# **Idle Insertion simulation results and state diagram improvements**

**Eric Lynskey**

# Update of action item

Figure 92-26—PCS Idle Insertion, input process state diagram

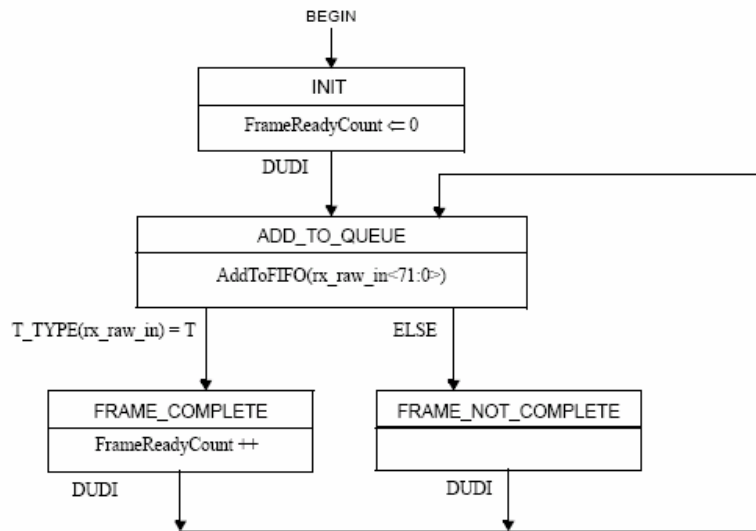
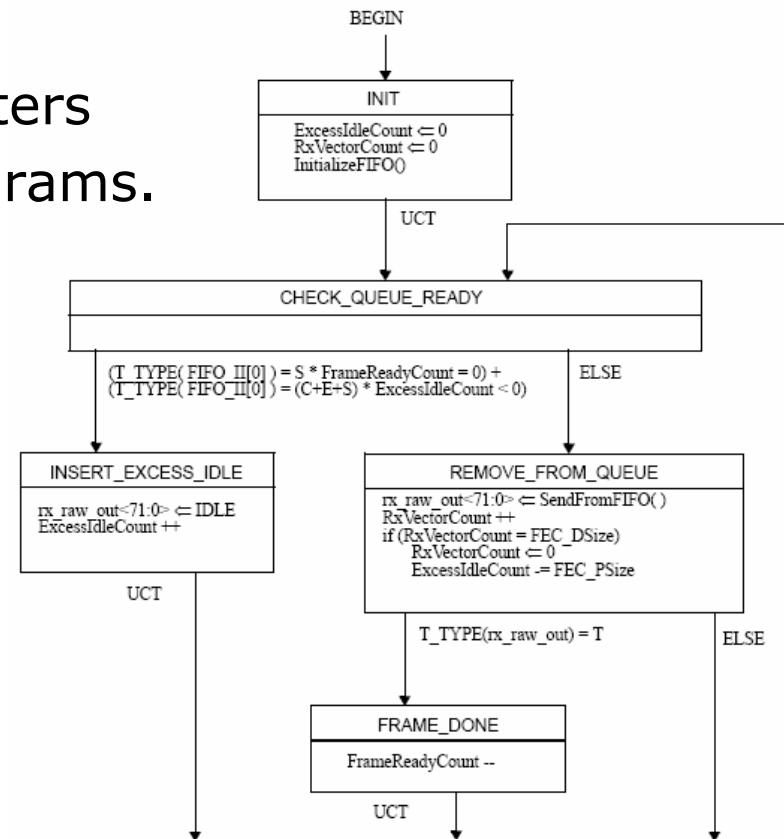
- The existing Idle Insertion mechanism in D1.8022 does not maintain a constant delay.
  - Frames of different lengths experience varying delays.
  - Frames of the same length experience varying delays.
  - Maximum delay variation approaches 70 TQ.
- The delay variation through the PMA and PCS must be kept to no more than 1 TQ.
- For MPCP to function properly the delay variation must be kept below 8 TQ.
- **Idle Insertion state diagram must be updated to reduce delay variation.**

- Large latency variation for different frame lengths.
- Large latency variation for frames of same length.
- Two diagrams with 9 total states.
- Complexity of functions and counters maintained by different state diagrams.

- Figure 92-26 and Figure 92-27 are merged into a single figure with fewer states.
- The following functions are removed:
  - AddToFIFO();
  - InitializeFIFO();
  - SendFromFIFO();
- The following counters are removed:
  - FrameReadyCount
  - ExcessIdleCount

- Simulations show that existing Idle Insertion state diagram can introduce an unacceptable amount of latency variation.
- A new state diagram has been presented.
- Simulations show that proposed Idle Insertion state diagram introduces a fixed amount of latency variation of 16 TQ.
- The Task Force should consider this state diagram as a replacement before heading into Working Group ballot.

Figure 1-1—PCS Idle Insertion

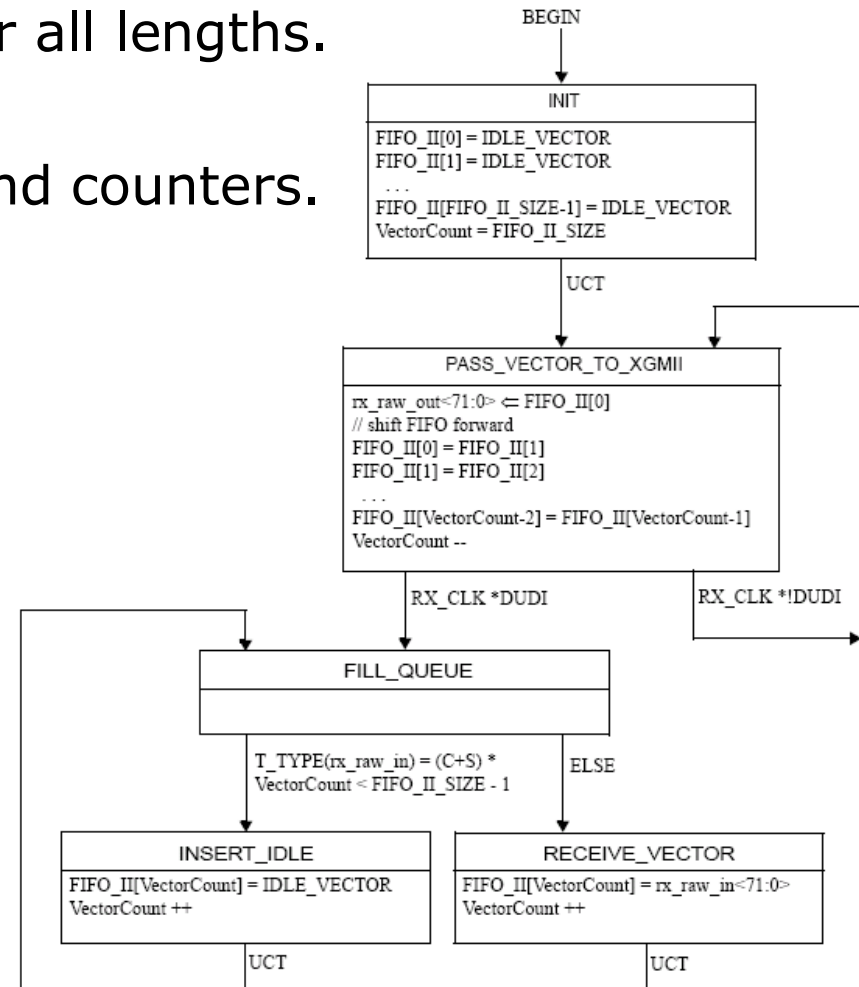
- Constant delay through FIFO for all lengths.
- One diagram with 5 states.
- Reduced number of functions and counters.

- Data rate leaving FIFO is 31 out of 31 XGMII clocks.
- Data rate entering FIFO is 27 out of 31 XGMII clocks.
- A maximum length frame of 2000 bytes can have up to 10 sets of parity inserted. Thus, up to 40 parity vectors can be removed by FEC decoder from one frame. FIFO needs to pre-buffer enough vectors (>40) in order to prevent run.
- General idea: When /S/ block arrives to the FIFO\_II, make sure it sees 40 vectors buffered ahead of it.
- How to do it: At the end of every frame, refill FIFO with IDLE to guarantee that the FIFO has 40 vectors in it.
- No matter what the length of the frame, it will receive a delay of 40 vectors. This corresponds to 16 TQ.

- **INIT state**
  - Initialize FIFO to all IDLE
- **PASS\_VECTOR\_TO\_XGMII**
  - Send head of FIFO to XGMII at constant rate
  - Advance FIFO
- **FILL\_QUEUE**
  - Determine whether to add data or fill with IDLE
- **INSERT\_IDLE**
  - Fill the rest of the FIFO with IDLE. State diagram will loop through FILL\_QUEUE and INSERT\_IDLE states until FIFO is full and before next DUDI.
- **RECEIVE\_VECTOR**
  - Add received data to FIFO

- After reset, initialize FIFO to be filled with IDLE.
- At every XGMII clock, transfer head of FIFO to XGMII.
- Add IDLE to FIFO until Start of first frame received.
- During frame, add data to FIFO.
- After frame refill FIFO with IDLE.
- FIFO size must be large enough to handle parity inserted with maximum length frame.
- Each Start of frame is inserted at bottom of FIFO and will have constant delay based on FIFO depth.
